**NRC Staff Responses to Public Comments on**  
**Draft Regulatory Guide DG-1146**  
**“A Performance-Based Approach to Define the Site-Specific**  
**Earthquake Ground Motion”**

This document contains NRC staff responses to comments received during the public comment period for Draft Regulatory Guide DG-1146, which ended on December 15, 2006. During this period, the NRC received the following sets of comments (in chronological order):

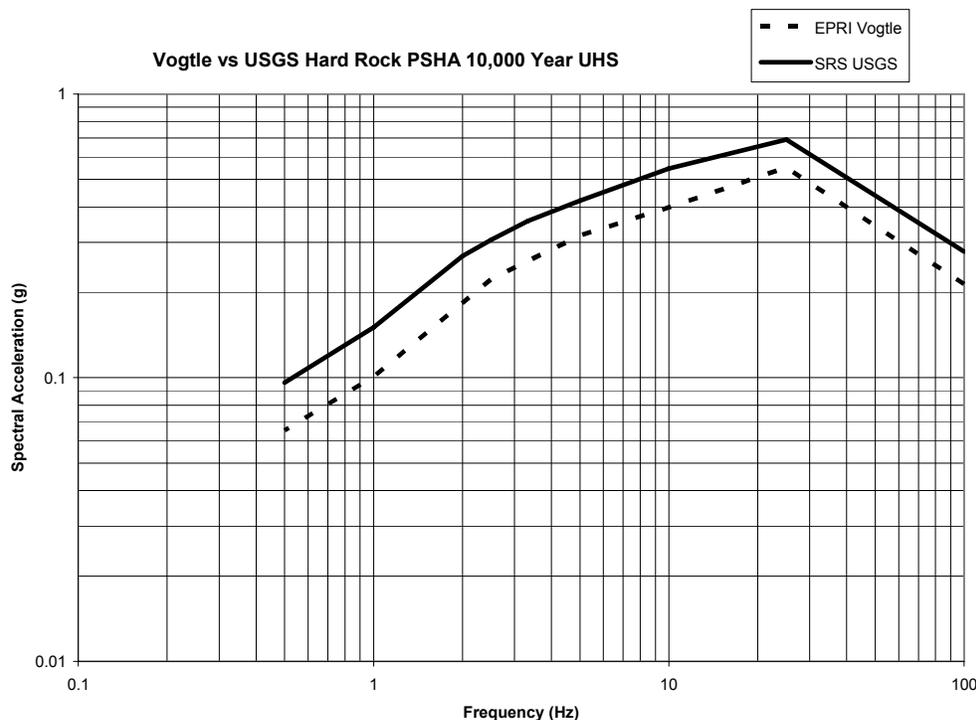
To compound these issues, the recent submission of the Vogtle ESP application, Site Safety Analysis Report, further demonstrates that PSHA stability does not exist. Consistent with other ESP applications (North Anna, Grand Gulf, Clinton), the Vogtle applicant has chosen to use an update to the EPRI PSHA to assess seismic hazard and establish appropriate ground motion for seismic design. The update to the EPRI PSHA for Vogtle, however, is significantly different than the EPRI PSHA work used by the preceding three ESP applicants, and inconsistent with material provided by EPRI as part of the ongoing dialog regarding resolution of seismic hazard issues (Program on Technology Innovation: Assessment of a Performance-Based Approach for Determining Seismic Ground Motions for New Plant Sites, V1 Performance-Based Seismic Design Spectra, V2 Seismic Hazard Result at 28 Sites; EPRI Technical Reports (1012044 and 1012045). Specific issues related to the EPRI PSHA update used for Vogtle are provided following the remaining comments.
